**DOCUMENT 00 90 00
ADDENDUM**

ADDENDUM: 3

PROJECT: WESTERN TECHNICAL COLLEGE
SPARTA PUBLIC SAFETY TRAINING SIM CITY
11177 COUNTY HWY 1
SPARTA, WISCONSIN 54656
PROJECT NO. 25039

E001

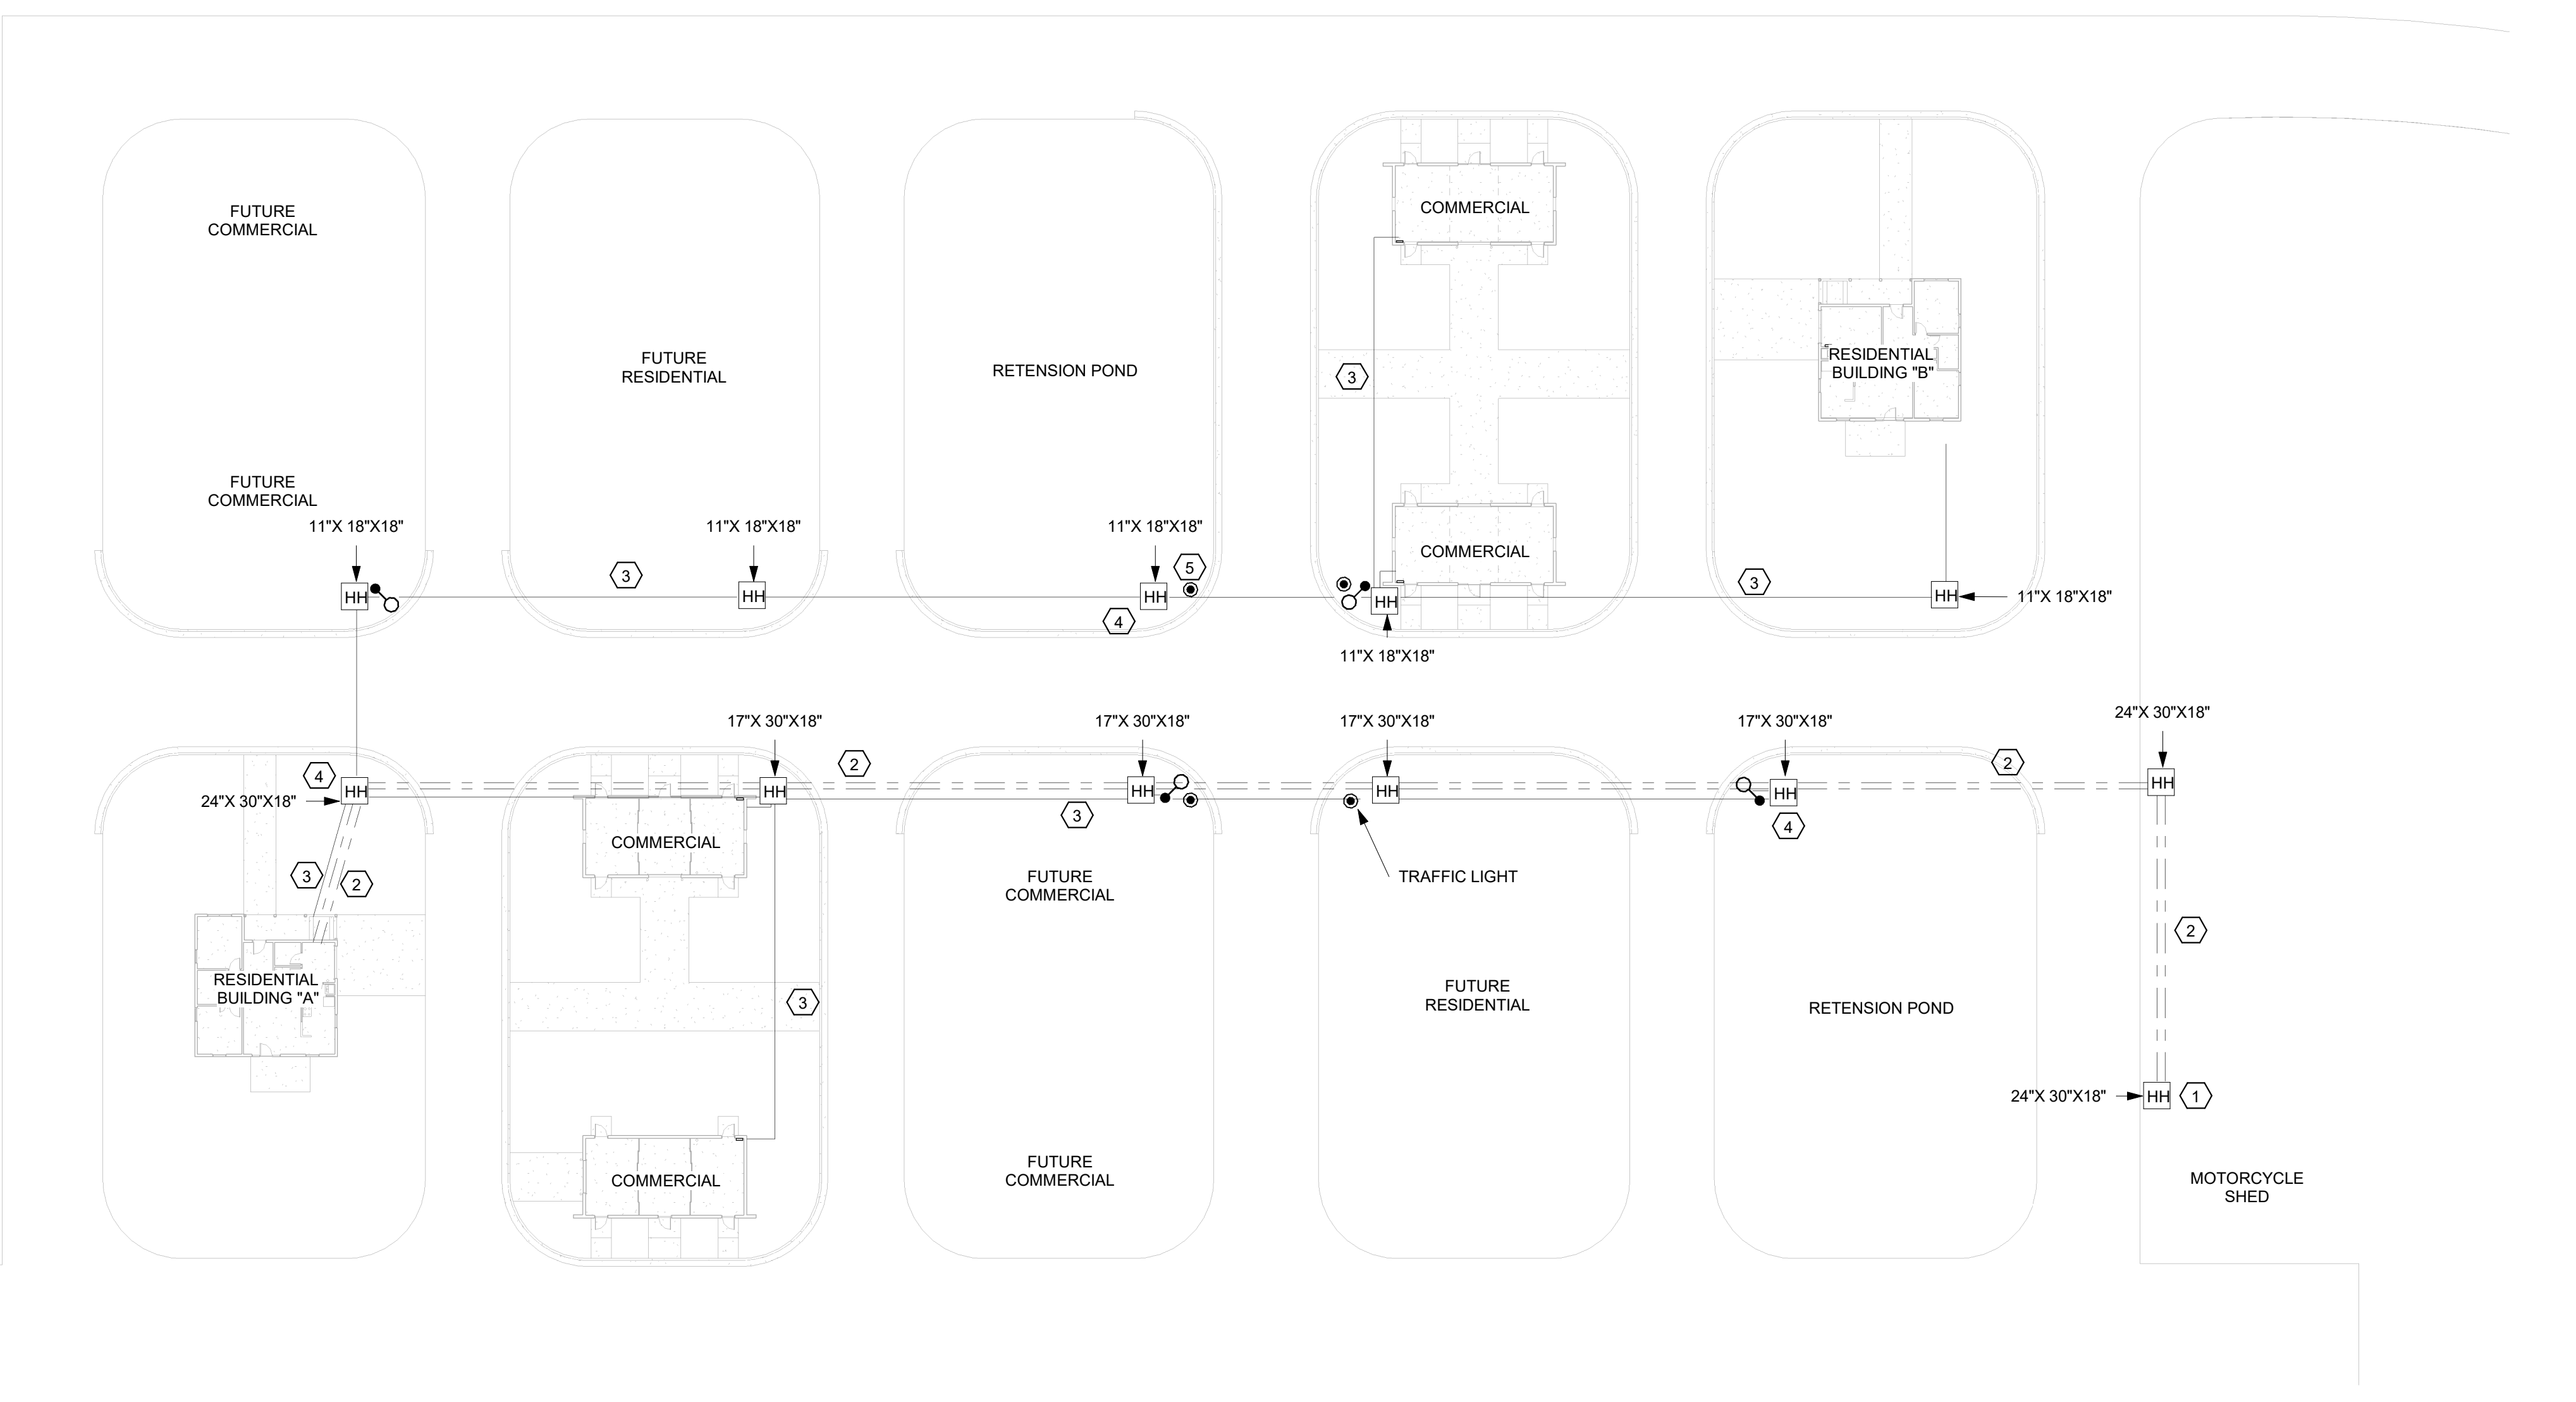
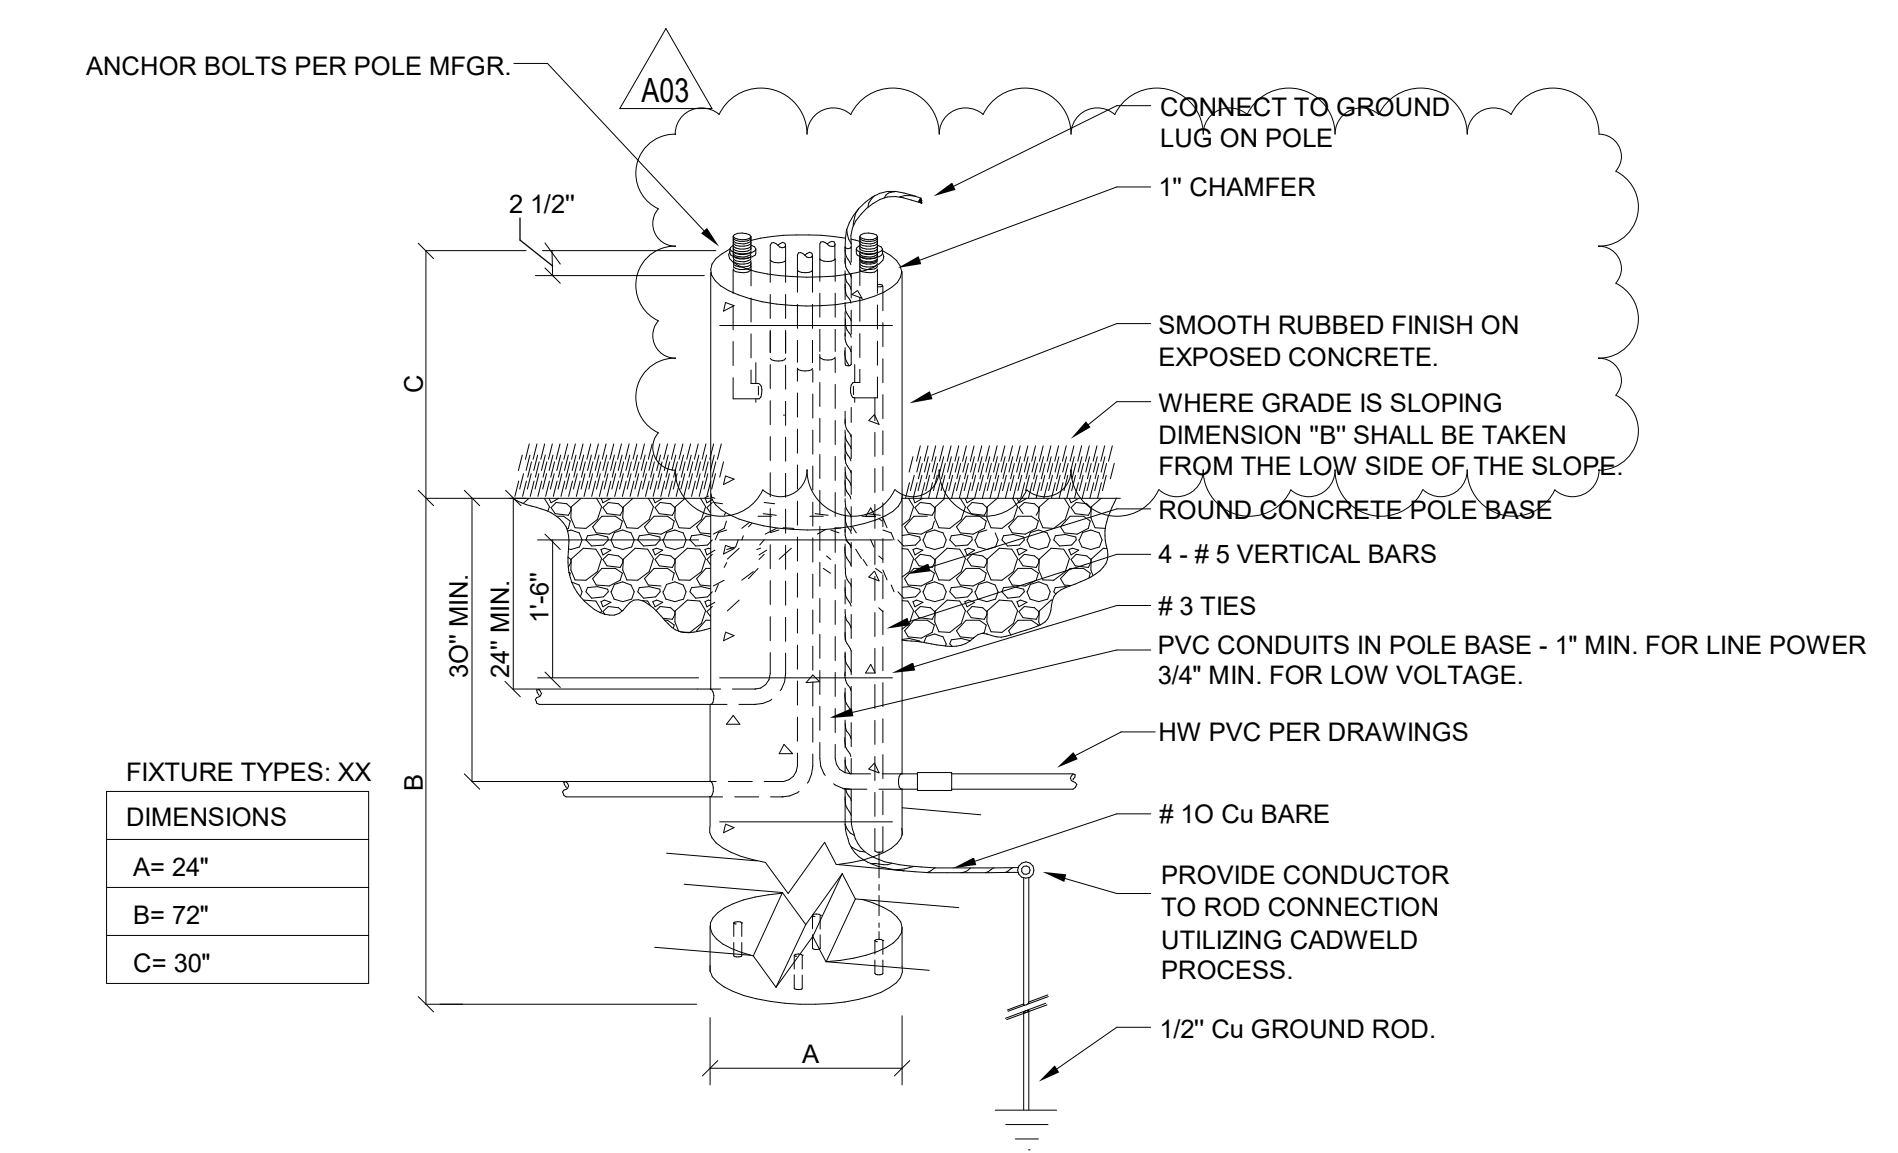
3. Sheet E001 SITE PLAN 21"x30"
 - a. See the revised sheet included in this addendum. Disregard the previous version.
 - b. Revised pole detail, site plan layout, and keynote. See clouded changes.
